**Standardization of technical and safety requirements in inland navigation:
European Code for Inland Waterways (resolution No. 24, revision 5)**

Outcome of the thirty-fourth and thirty-fifth meetings of the CEVNI Expert Group

Decisions of the thirty-fourth meeting of the CEVNI Expert Group

Decisions of the thirty-fourth meeting of the CEVNI Expert Group

(fig. 3 bis)

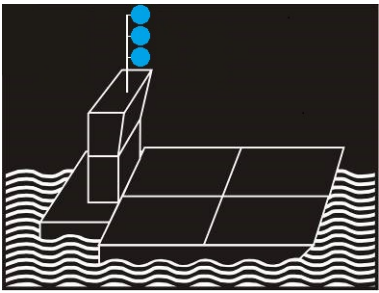
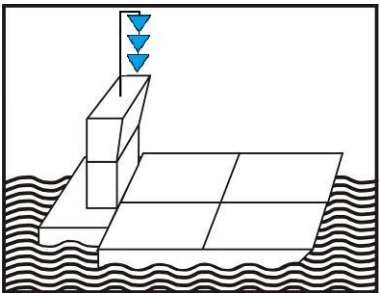
- Add figures 3 bis and 3 ter

Buoys for separating the berthing area on the right-hand side of the fairway

1.E Buoy with light for marking the fairway adjacent to a berthing area

Colour: red
Form: cylindrical buoy
Topmark (if any): no
Light (when fitted): rhythmic red light with a rhythm different from that of the lights of other buoys placed along the fairway limits.

Buoys for separating the berthing area on the left-hand side of the fairway

2.E Buoy with light for marking the fairway adjacent to a berthing area (fig. 3 ter)

- Colour: green
- Form: conical buoy
- Topmark (if any): no
- Light (when fitted): rhythmic green light with a rhythm different from that of the lights of other buoys placed along the fairway limits.

6. If a berthing area adjacent to the fairway, in addition to the signs prescribed in paragraphs 1 to 5 above or in article 7.06, is separated from the fairway with buoys, it shall be indicated by:

- On the right-hand side of the fairway: buoys with lights shown on figure 3 bis, annex 8;
- On the left-hand side of the fairway: buoys with lights shown on figure 3 ter, annex 8.

| | 34 bis | |

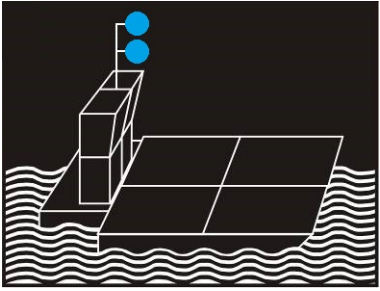
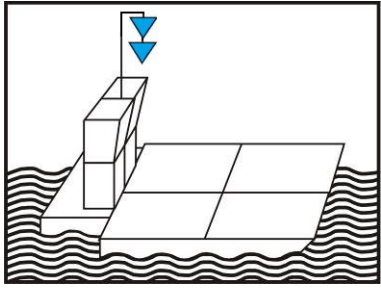
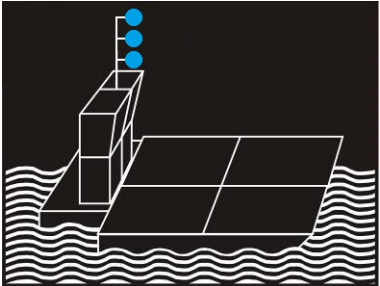
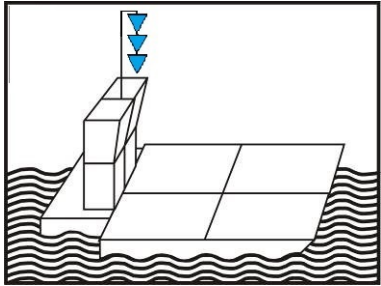
- Add new sketches 34 bis and 34 ter:

| Article 3.14, paragraph 4: Additional marking of pushed convoys carrying out certain transport operations involving dangerous substances, prescribed in article 3.14, paragraph 2, in accordance with the requirements of sub-section 7.1.5.0 or sub-section 7.2.5.0 of ADN and chapter 3.2, table A, column (12) or table C column (19) of ADN. | | |

| <p>Article 3.14, paragraph 4: Additional marking of pushed convoys carrying out certain transport operations involving dangerous substances, prescribed in article 3.14, paragraph 3, in accordance with the requirements of sub-section 7.1.5.0 or sub-section 7.2.5.0 of ADN and chapter 3.2, table A, column (12) or table C column (19) of ADN.</p> | | |

|  | 35 bis |  |

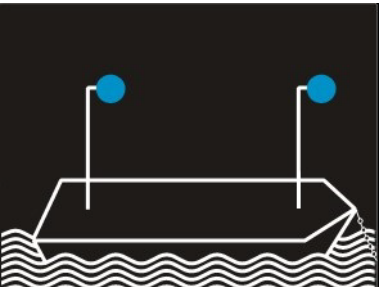
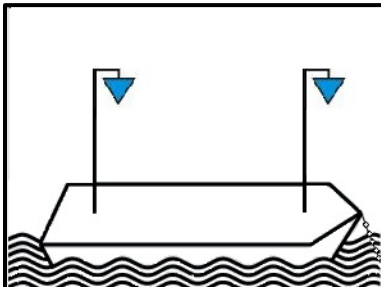
• Add new sketches 35 bis and 35 ter:

| <p>Article 3.14, paragraph 4: Additional marking of side-by-side formations carrying out certain transport operations involving dangerous substances, prescribed in article 3.14, paragraph 2, in accordance with the requirements of sub-section 7.1.5.0 or sub-section 7.2.5.0 of ADN and chapter 3.2, table A, column (12) or table C column (19) of ADN.</p> | | |
| <p>Article 3.14, paragraph 4: Additional marking of side-by-side formations carrying out certain transport operations involving dangerous substances, prescribed in article 3.14, paragraph 3, in accordance with the requirements of sub-section 7.1.5.0 or sub-section 7.2.5.0 of ADN and chapter 3.2, table A, column (12) or table C column (19) of ADN.</p> | | |

|  | 36 bis |  |

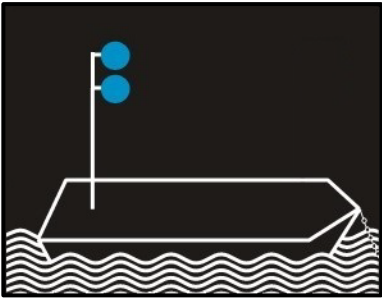
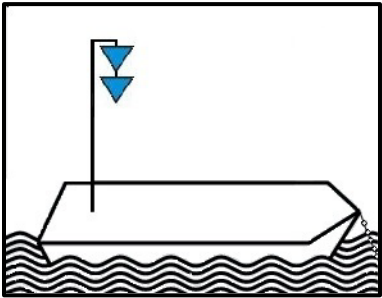
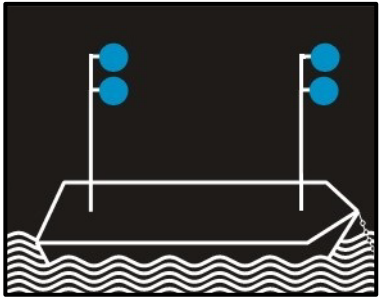
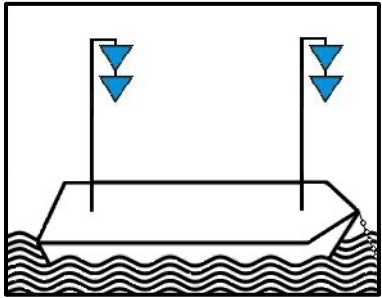
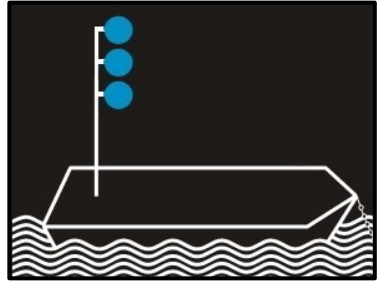
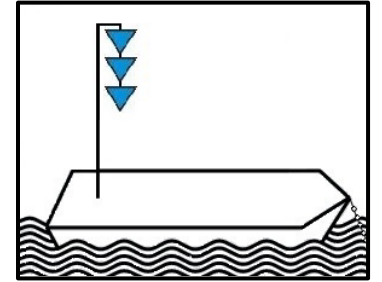
- Add new sketches 36 bis and 36 ter:

| <p>Article 3.14, paragraph 5: Additional marking of pushed convoys propelled by two pushers placed side by side and carrying out certain transport operations involving dangerous substances, prescribed in article 3.14, paragraph 2, in accordance with the requirements of sub-section 7.1.5.0 or sub-section 7.2.5.0 of ADN and chapter 3.2, table A, column (12) or table C column (19) of ADN.</p> | | |
| <p>Article 3.14, paragraph 5: Additional marking of pushed convoys propelled by two pushers placed side by side and carrying out certain transport operations involving dangerous substances, prescribed in article 3.14, paragraph 3, in accordance with the requirements of sub-section 7.1.5.0 or sub-section 7.2.5.0 of ADN and chapter 3.2, table A, column (12) or table C column (19) of ADN.</p> | | |

|  | 49 bis |  |

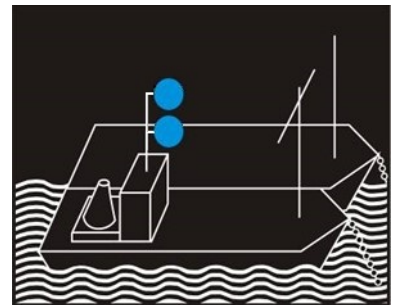
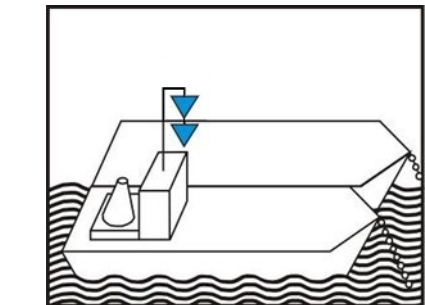
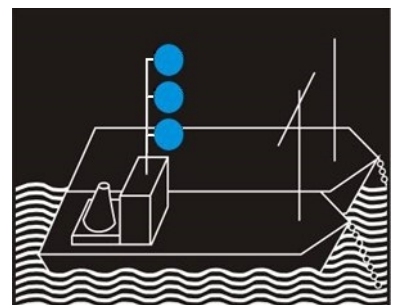
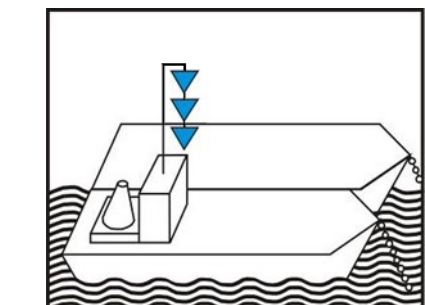
- Add new sketches 49 bis – 49 quinquies

| <p>Article 3.21: Additional marking for stationary vessels carrying out certain transport operations involving dangerous substances in accordance with article 3.14, paragraph 1.</p> | | |

| Article 3.21: Additional marking for stationary vessels carrying out certain transport operations involving dangerous substances in accordance with article 3.14, paragraph 2. | | |
| Article 3.21: Additional marking for stationary vessels carrying out certain transport operations involving dangerous substances in accordance with article 3.14, paragraph 3. | | |
